COMMISSION OF ARCHITECTURAL REVIEW
STAFF REPORT
June 26, 2018, Meeting

7. COA-034556-2018 (R. Wise)

411 Chimborazo Blvd
Chimborazo Park Old and Historic District

Construct a new, 2-story frame garage.

1950 Sanborn Map

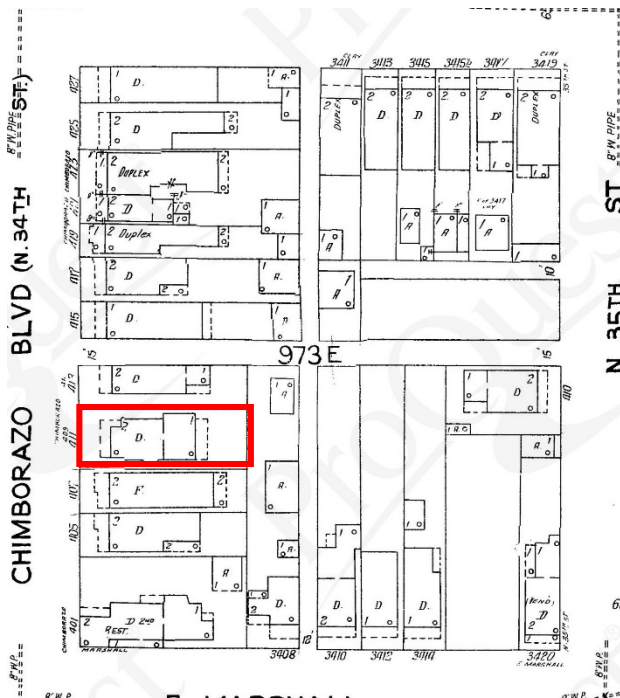
Surrounding Context: The garage is located to the rear (east) of 411 Chimborazo Boulevard and fronts on a north-south running alley. A new dwelling was recently approved for the lot (413) to the north which is adjacent to an east-west running alley. There are no other garages facing the alleys and a few 1-story sheds. The 1950 Sanborn Map indicates that there were several 1-story garages fronting on the alley. There is an existing 1-story shed on the property, non-historic, that is being removed.
